Addendum No. 2

Project: Fort Wayne International Airport
Construct Taxiway G Extension & Demolish Taxiway C2
AIP No. 3-18-0022-XX

Date: June 20, 2024

Drawing No.: **G2.0.1**

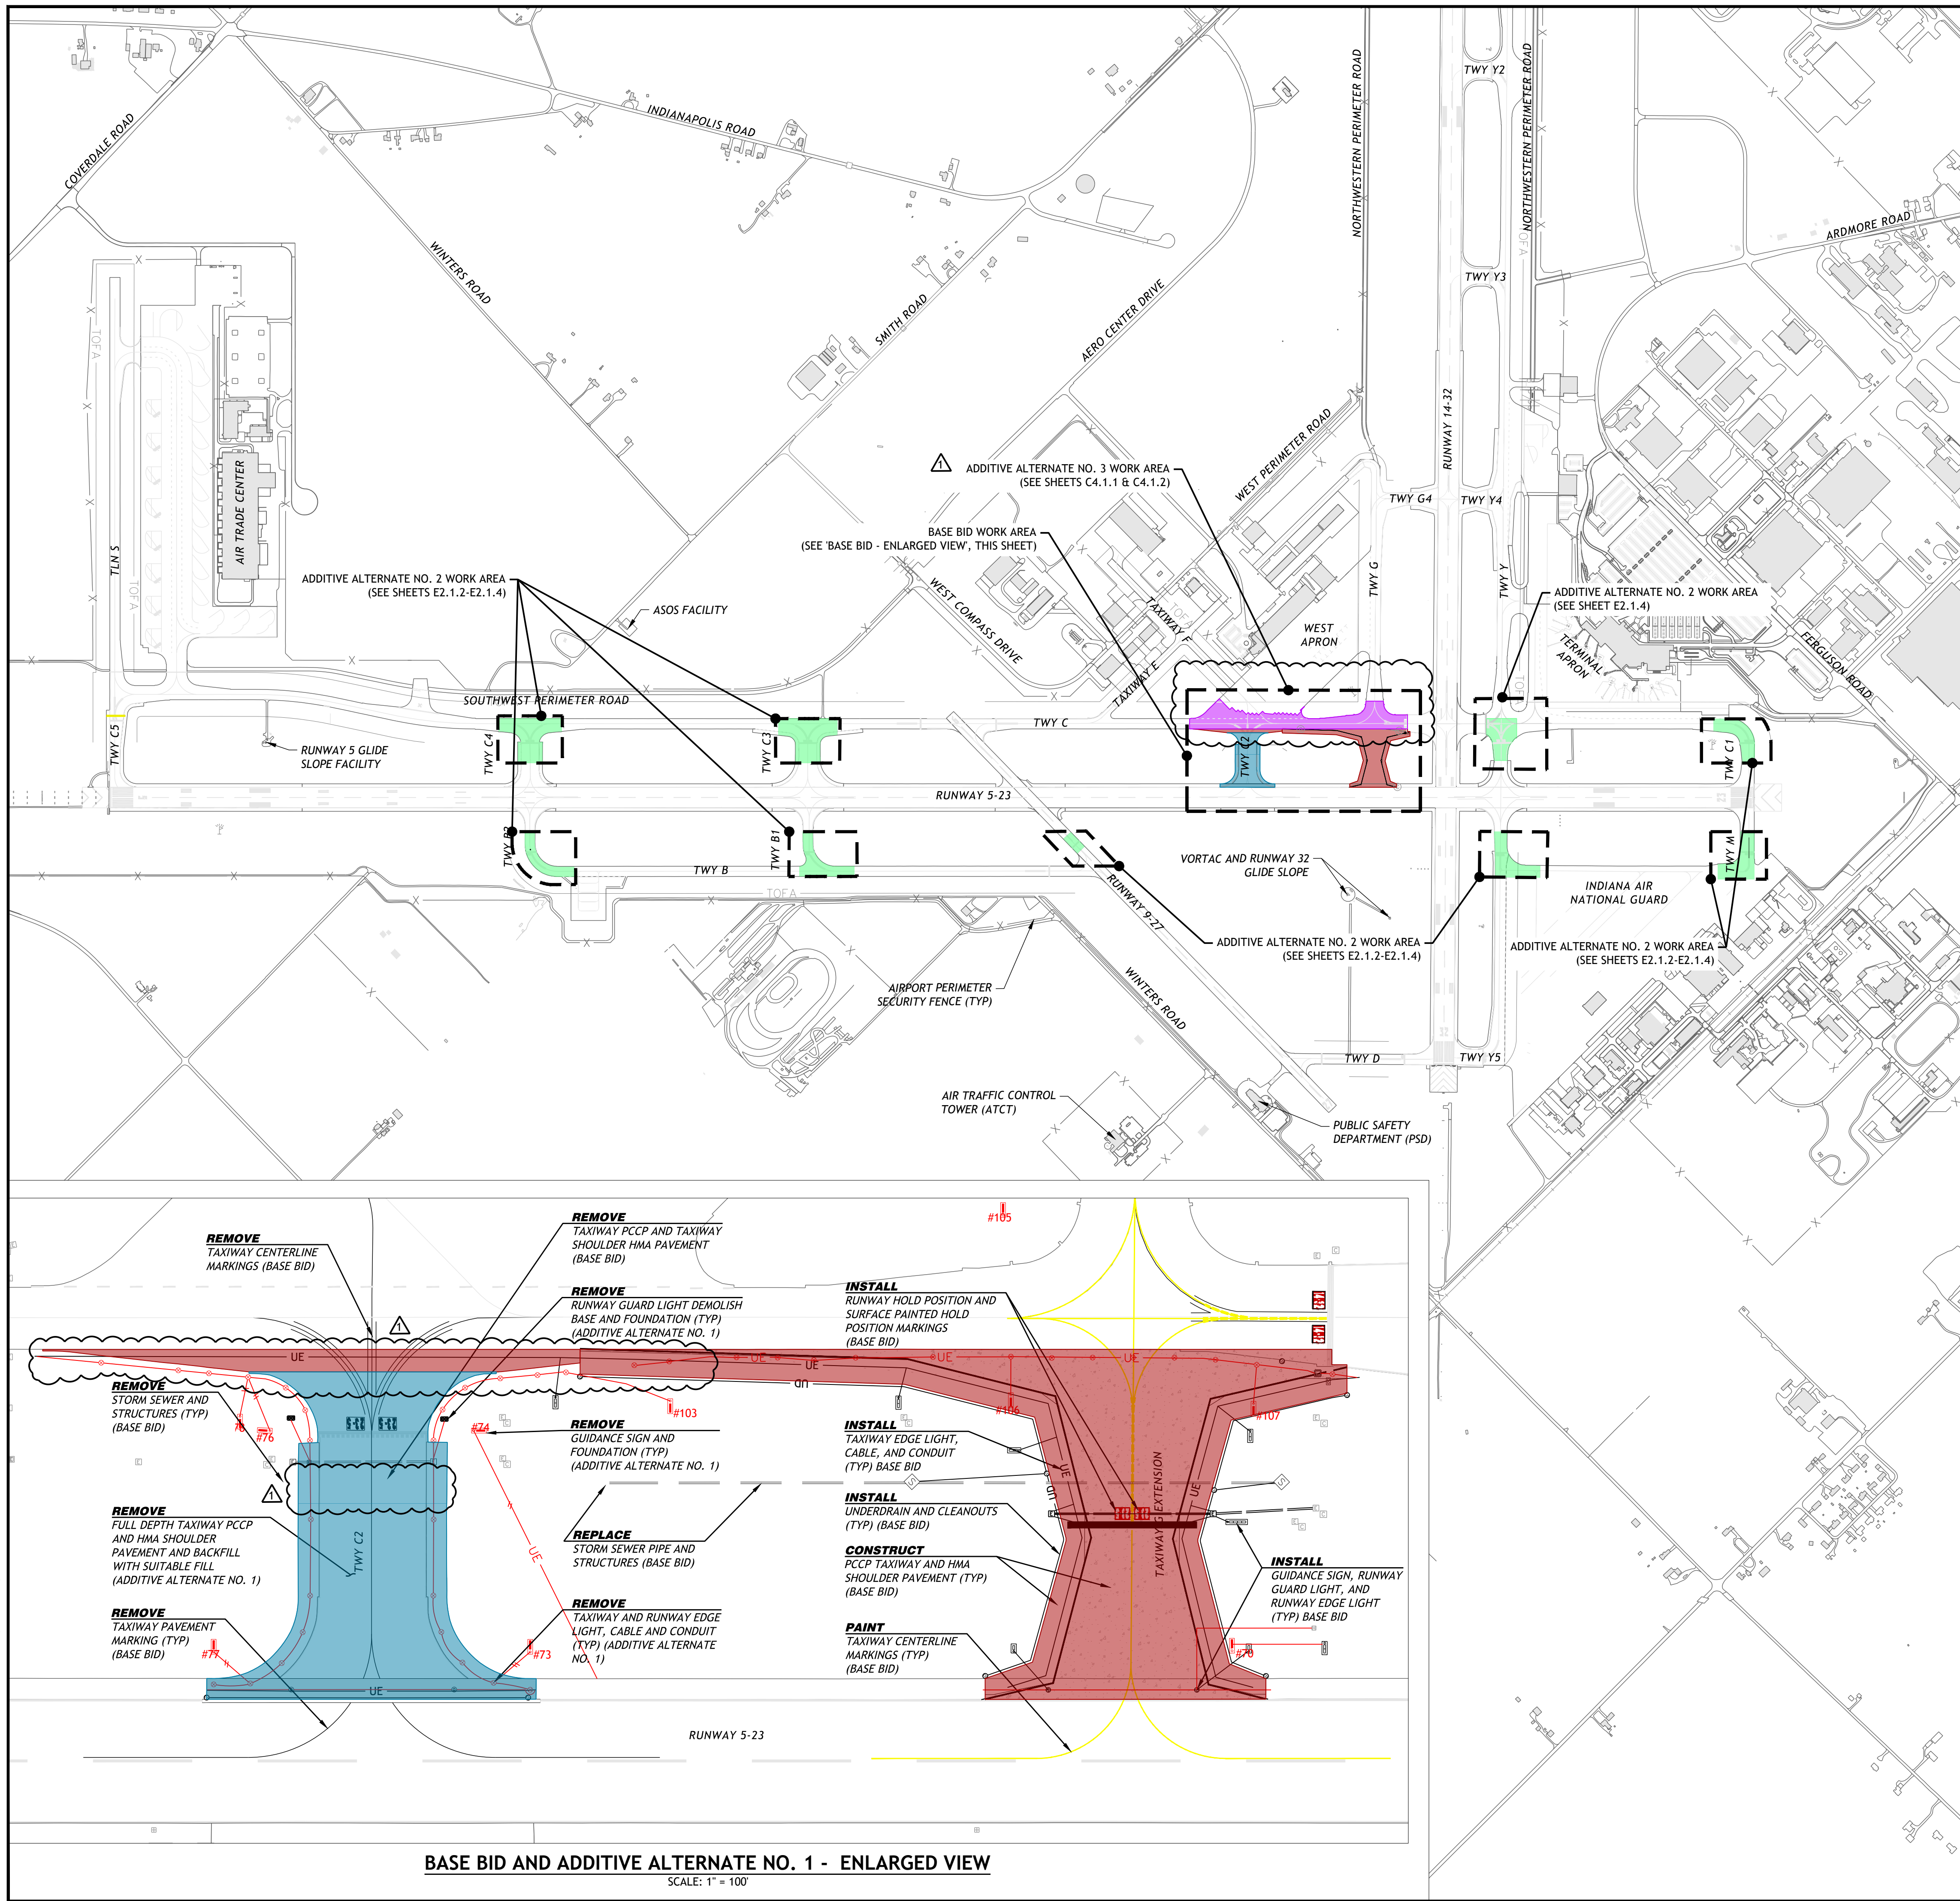
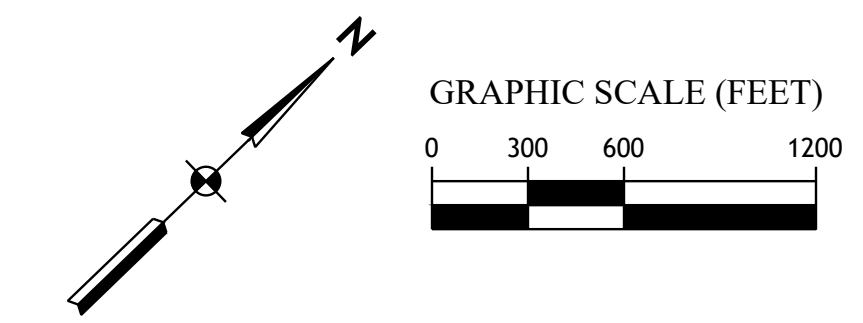
Reissued: Scope of Work plan has been reissued with this Addendum to convey the addition of Additive Alternate No. 3 related to the repairs and rehabilitation of Taxiway C between the West Apron and Runway 14-32.

Designed By: RB	Drawn By: KDR	Checked By: NSL
Issue Date: 05/28/2024	Project No: 075494	Scale: AS SHOWN
Drawing No.: G4.0.1

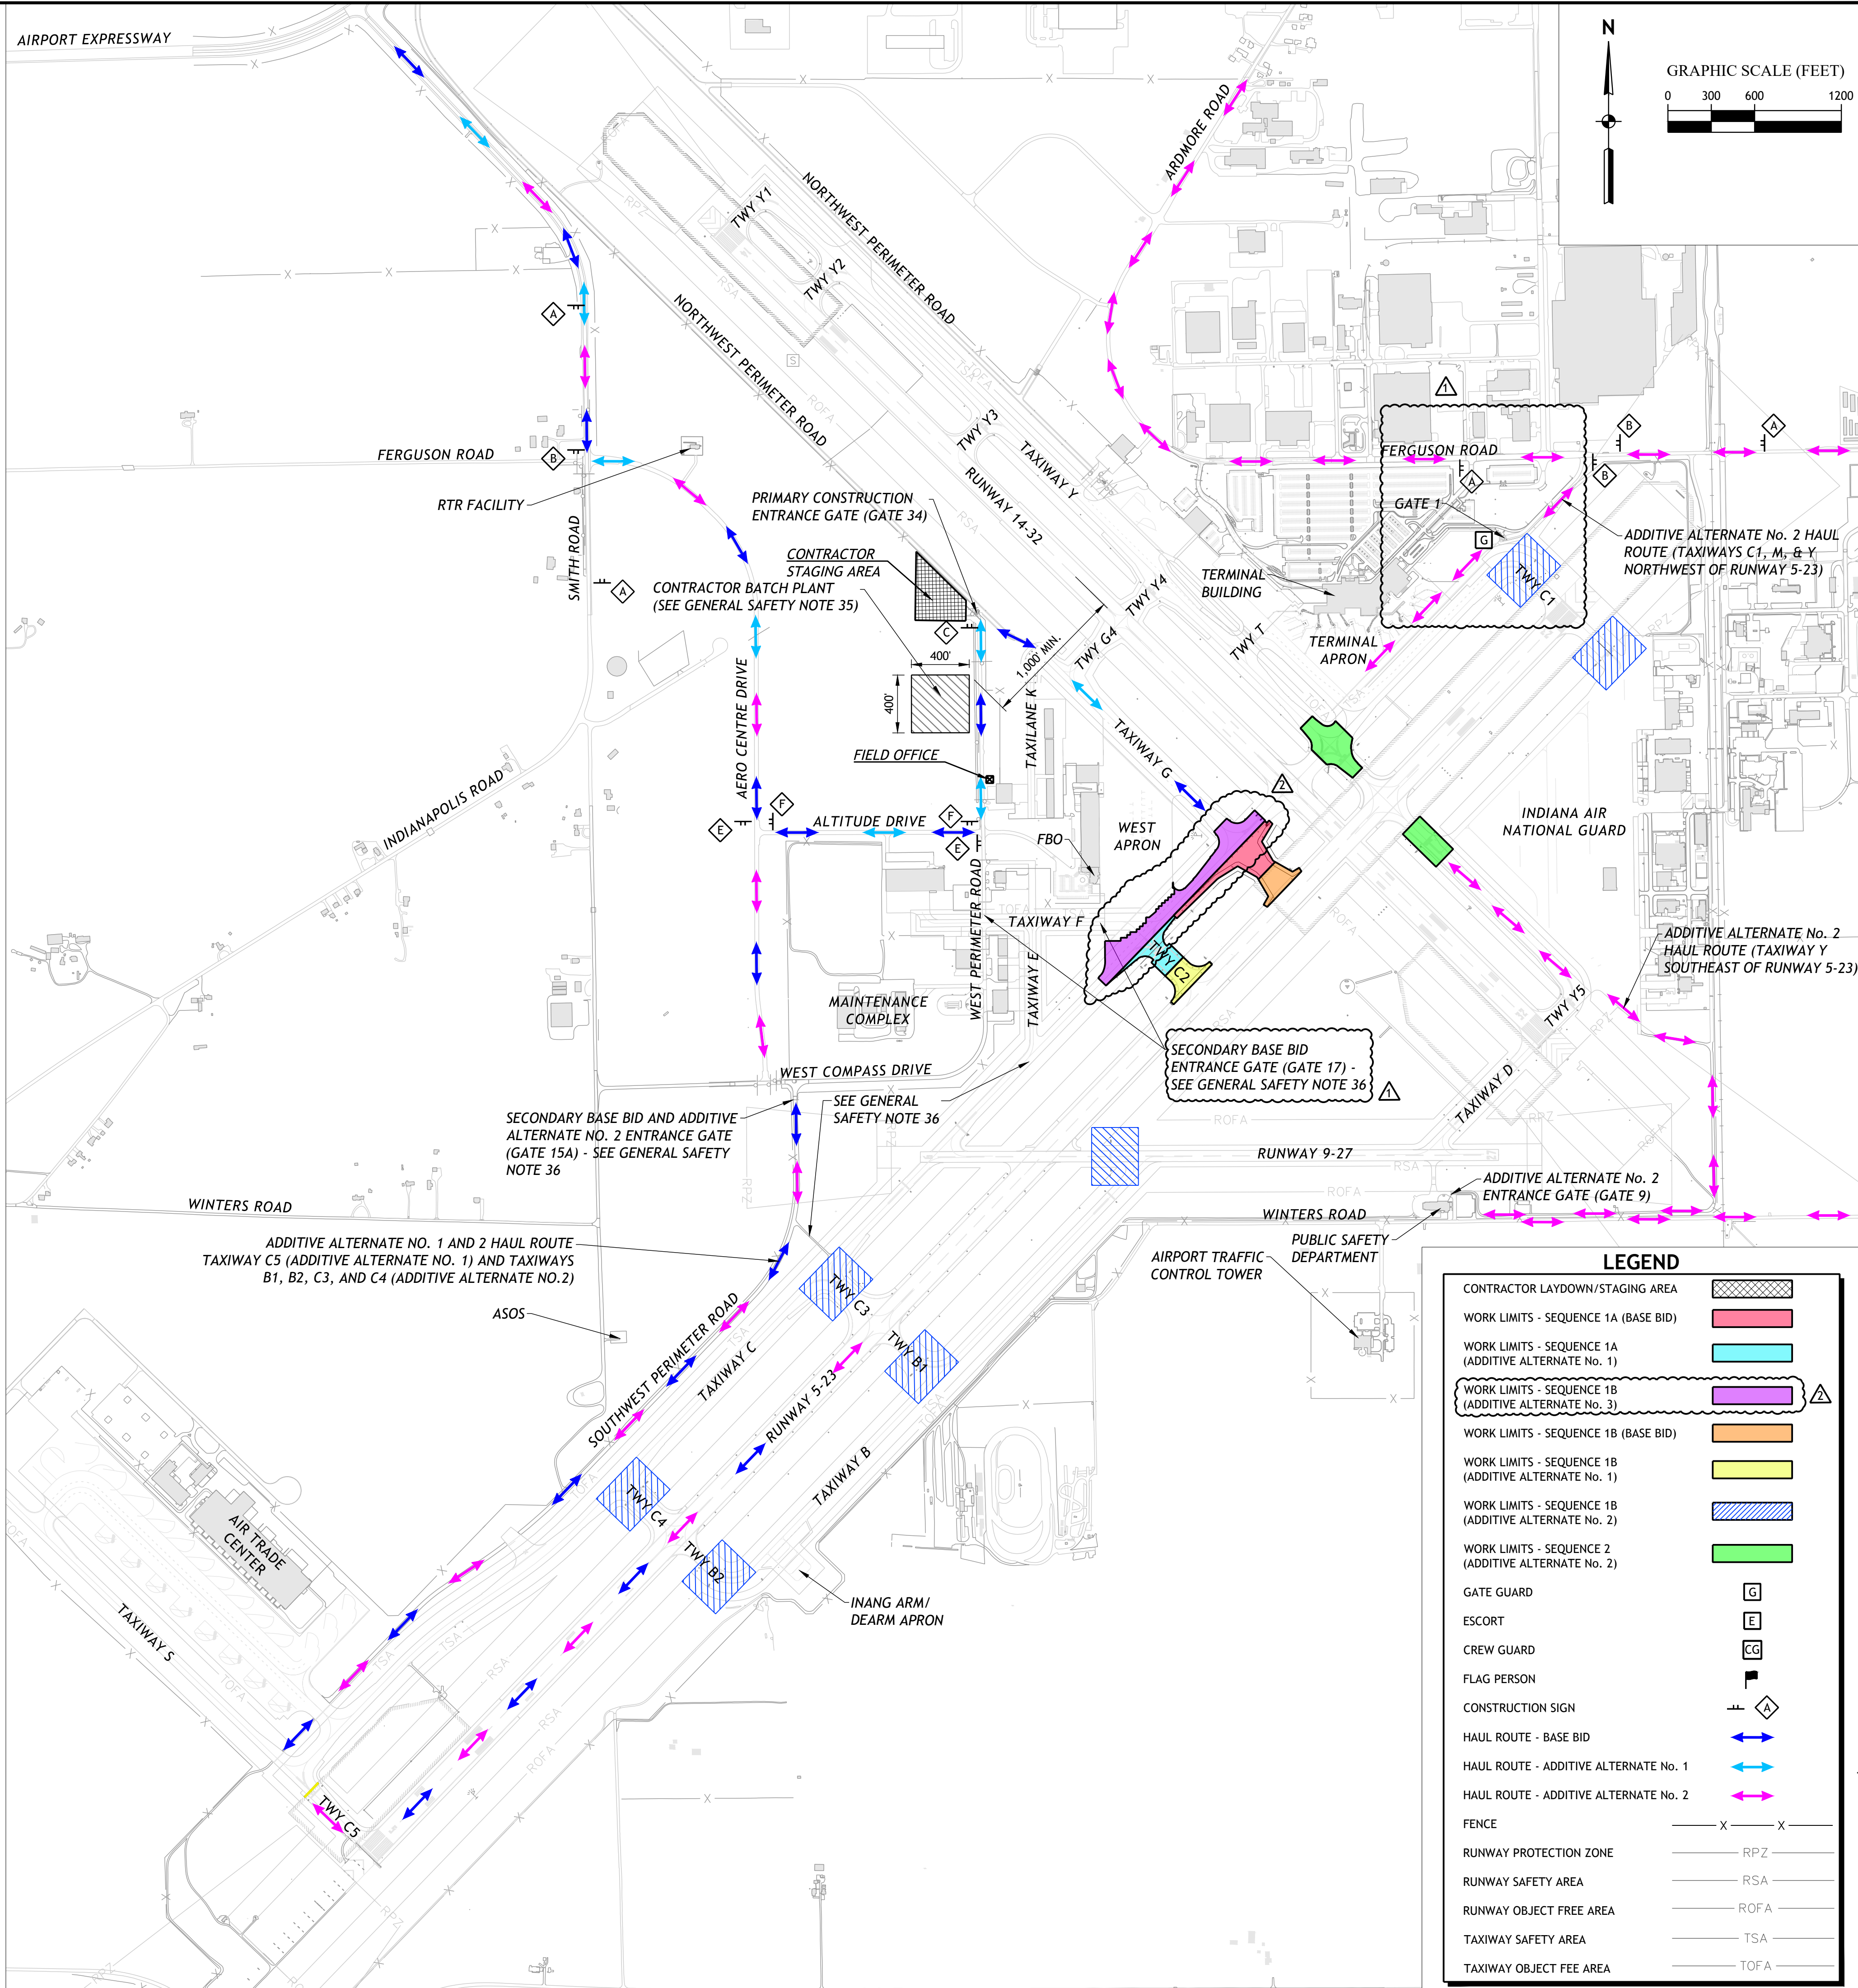
Reissued: This sheet as been revised to include the delineation of the work area associated with Additive Alternate No. 3, located between the West Apron and Runway 14-32 on Taxiway C.
